ADMINISTRATIVE AMENDMENT
LEE COUNTY, FLORIDA

WHEREAS, Lee County Homes Associates I, LLLP filed an application for an administrative amendment to a Residential Planned Development on a project known as Lee County Homes FKA Buckingham 320 RPD to amend the Master Concept Plan to correct and modify the buffers along the western property boundary and surrounding a potential school site on property described as:

1. **The Development must be in compliance with the amended Master Concept Plan, dated 05/27/2021. Master Concept Plan for ADD2021-00086 is hereby APPROVED and adopted. A reduced copy is attached hereto.**

MASTER CONCEPT PLAN

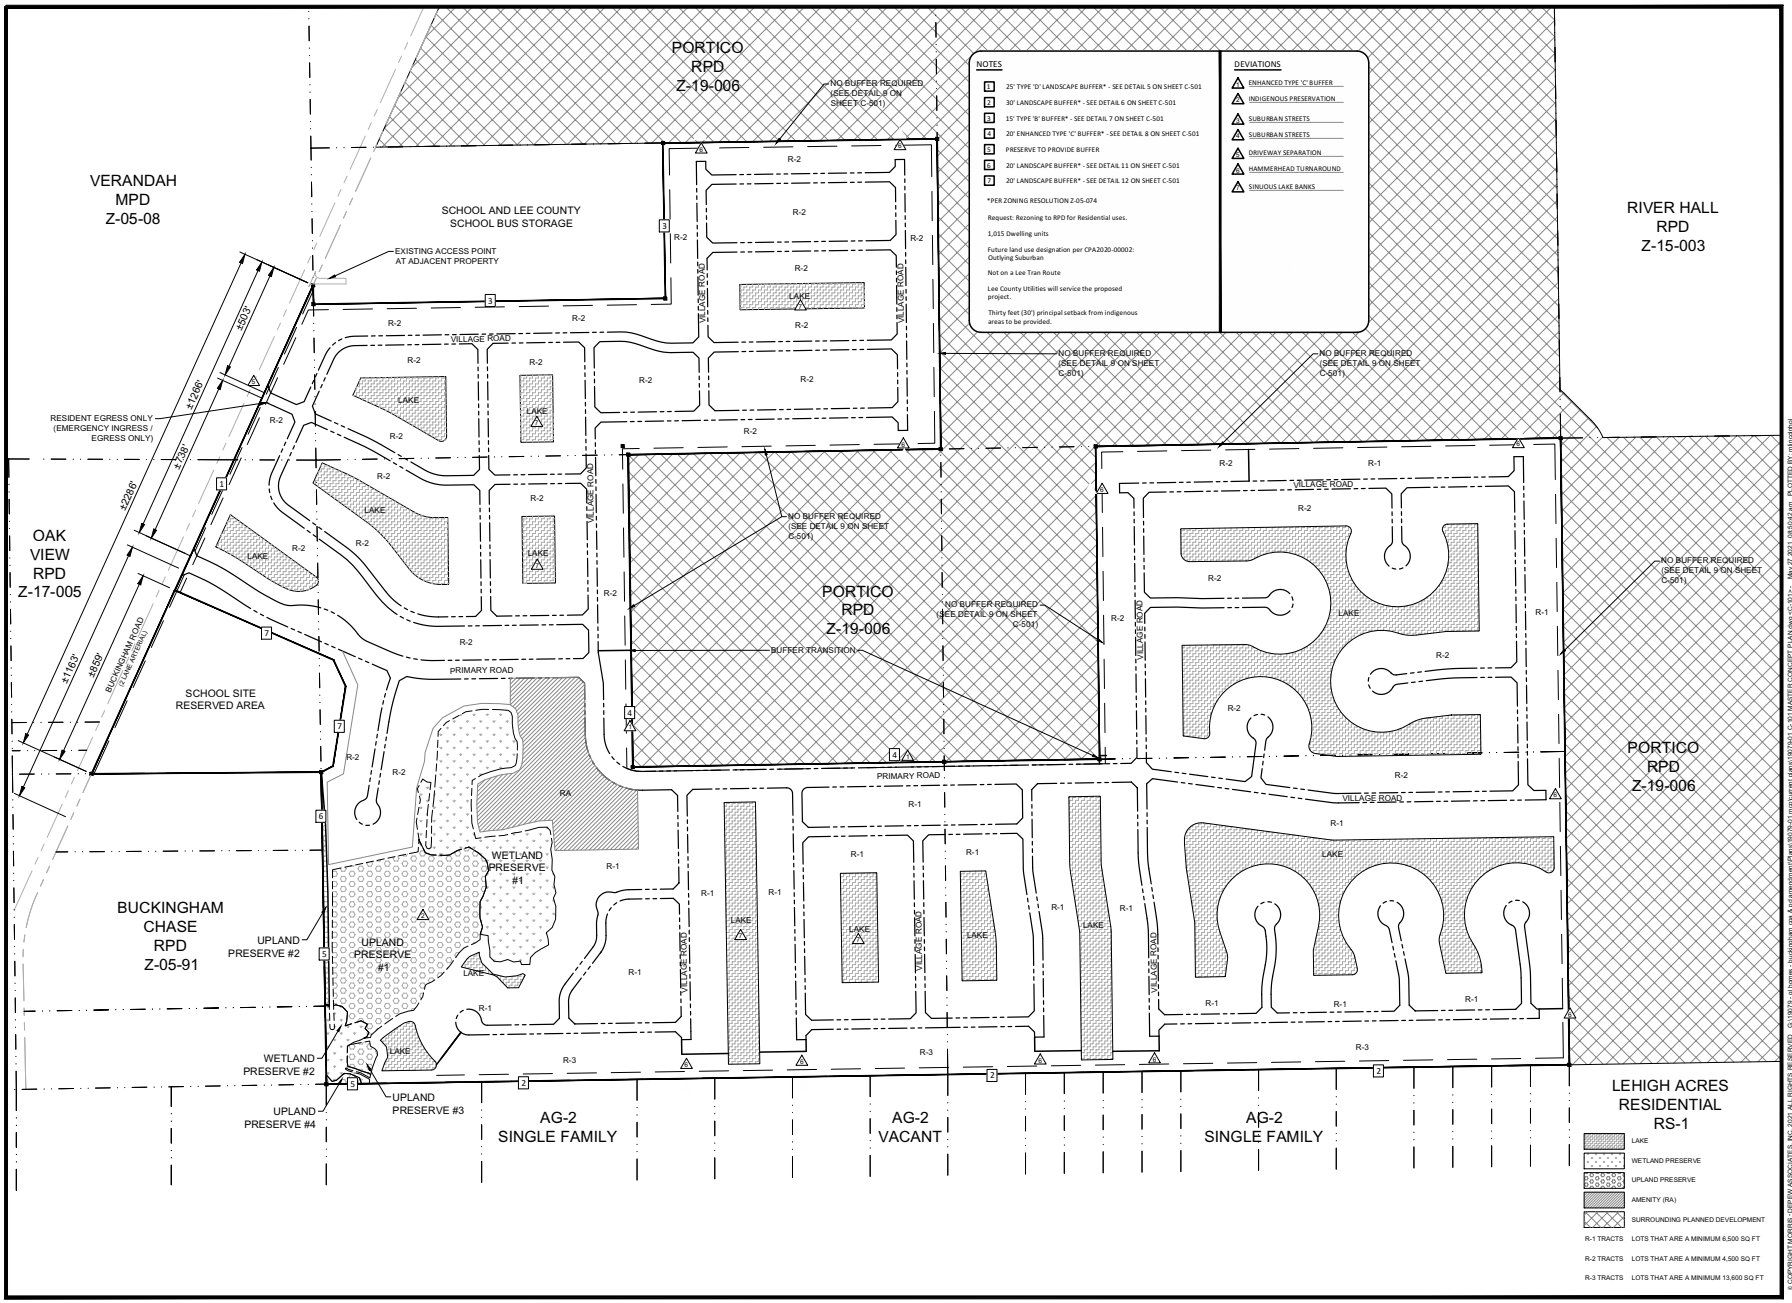
WHEREAS, the applicant requests to amend the buffers along the western property boundary and the also between the development and the potential school site to the west; and

WHEREAS, the applicant proposes to reduce the width of the landscape buffers in the above mentioned locations from 30 feet to 20-foot wide buffers; and

WHEREAS, the Master Concept Plan approved as a part of resolution Z-21-002, Note #2, depicts the 30-foot-wide enhanced buffer intended for the southern property boundary was erroneously extended north and around the school site; and

12 WESTERN BUFFER ADJACENT TO SCHOOL SITE

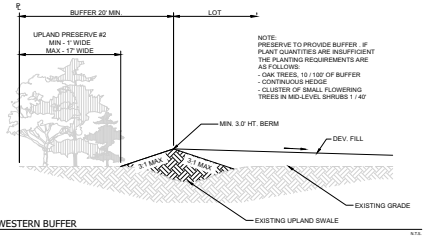
d. Buffer Adjacent to the School Site and Buckingham Chase RPD

Development order plans must depict an enhanced 20-foot buffer. Existing indigenous native vegetation may be counted toward the vegetation requirements of this condition. The enhanced buffer must include the following:

i. A minimum three-foot-in-height berm;

ii. Ten Live Oak (*Quercus virginiana)* per 100 linear feet;

iii. Continuous hedge row; and

iv. One mid-story flowering tree per 40 linear feet
